**STAFF REPORT
WEST ALLIS PLAN COMMISSION
Wednesday, April 26, 2023
6:30 PM**

7. Creative Signage Plan for McCoco's, an existing restaurant at 7420 W. Greenfield Ave. (Tax Key No. 440-0413-000)

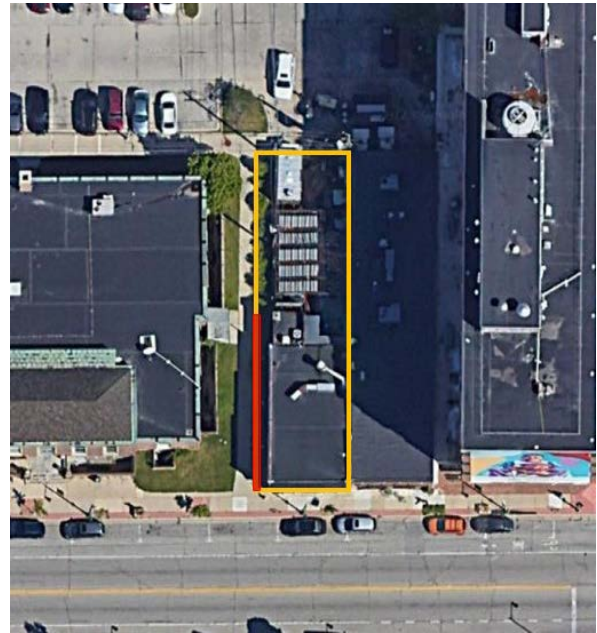
A concept image of the proposed signage has been provided by the applicant. Shown on the concept plan is the palm tree sign on the southwest wall of the building, visible from Greenfield Ave. Shown on the palm tree is a depiction of the restaurant's name. Two birds are shown alongside the wall. It is unclear whether the applicant intends these birds to be within the proposed mural, or as signage applied to the wall. The concept image depicts colors on the signage. Any signs with electricity must be listed by a nationally recognized testing laboratory or be evaluated by a third-party engineer to be placed outside.

The applicant also provided a concept image of the proposed mural on the west façade. Shown on the mural is a tropical sunset to match the overall Caribbean theming of the existing restaurant. The applicant did not specify whether the mural will be painted or applied to the wall in a different method.

1. A revised Sign Plan being submitted to the Planning and Zoning Office to indicate the following:
 - a. Notation on the sign plan to indicate the total number of signs proposed on the west façade of the existing building.
 - b. Notation on the sign plan to indicate method of application for the proposed mural along with details including dimensions, timing of installation, and artist.
 - c. Notation on the sign plan to indicate electrification of the proposed signage. All signs with electricity must be listed by a nationally recognized testing laboratory or be evaluated by a third-party engineer to be located on the exterior.
2. Removal of the noncomplying "Open" sign on the entrance of the south façade before installation of any additional signage.
